SUBJECT:
SOFTWARE / FIRMWARE UPDATE

MODEL: C4MF

SUBJECT: AC HARNESS MODIFICATION

SUBJECT: Inverter Misfeed

The diagrams on page 2 of 2 show the point to point wiring of the old and new circuits. Please update the point to point diagram in the service manual.

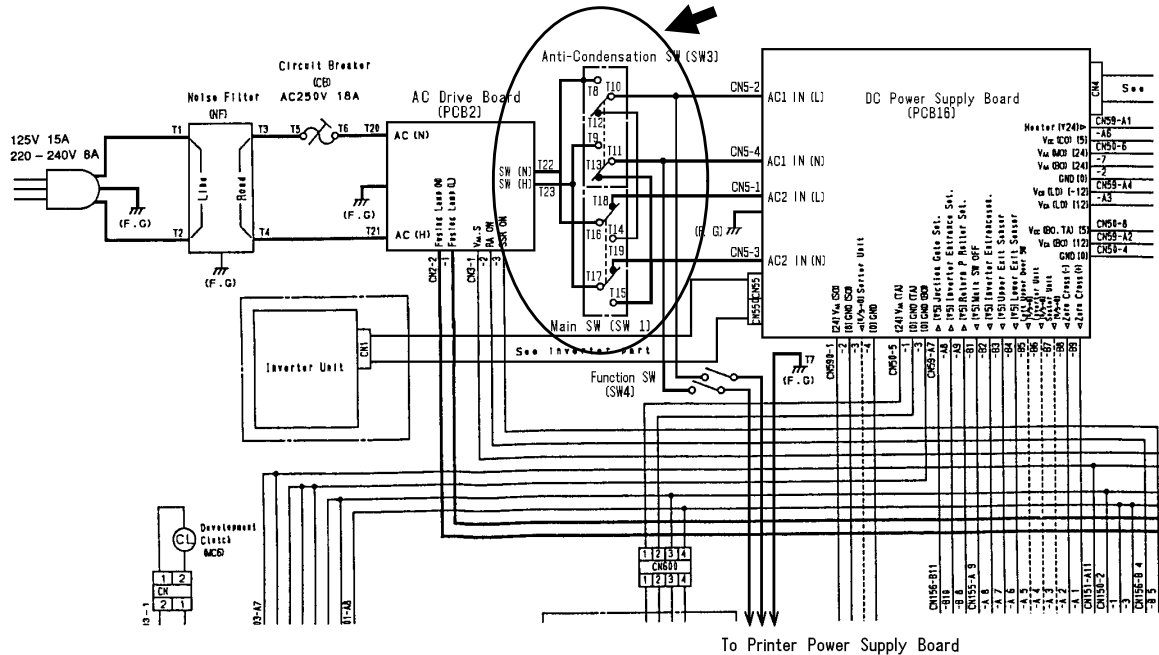
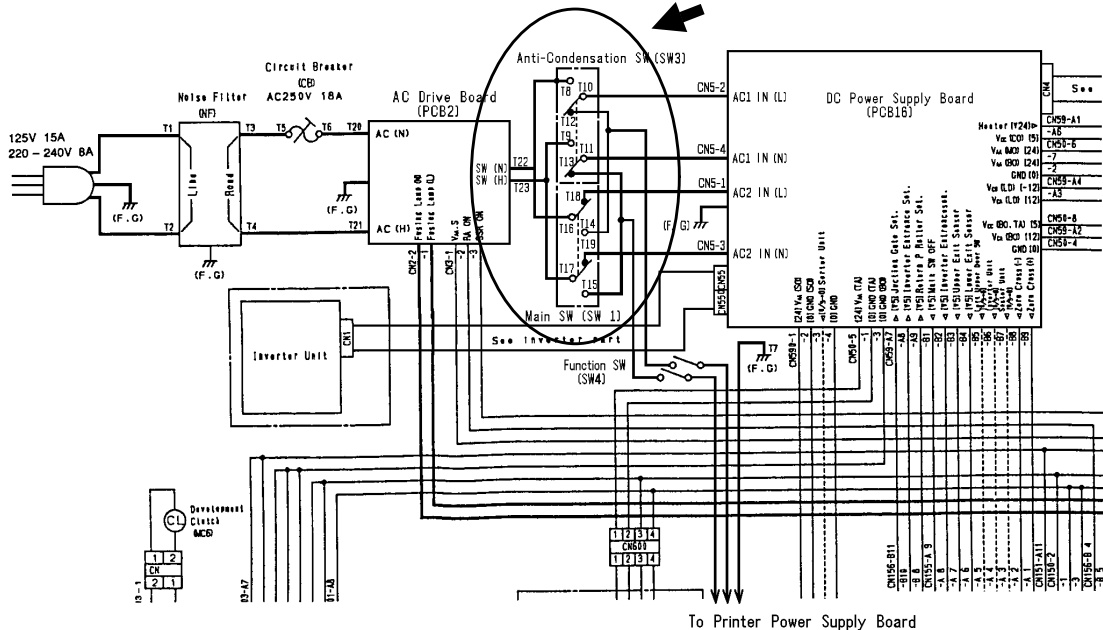
To eliminate the necessity of turning off and on the anti-condensation switch the ac harness (Part Number : A0995501) has been modified from July 1994 production.

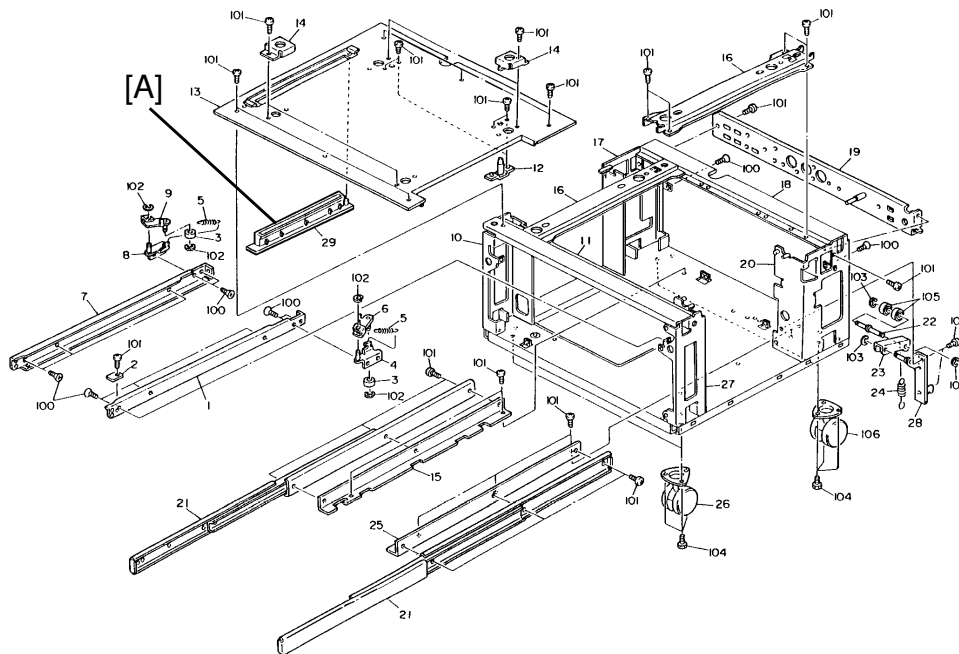
A paper misfeed occurs in the inverter unit and the Misfeed Location indicator D and E light.

The paper entrance guide [A] on the LCT / duplex unit or the LCT unit is out of position and interferes with paper movement.

1. Open the left cover on the LCT / duplex unit or the LCT.
2. Push and snap up both the front and rear of the paper entrance guide and make sure that it is positioned properly.
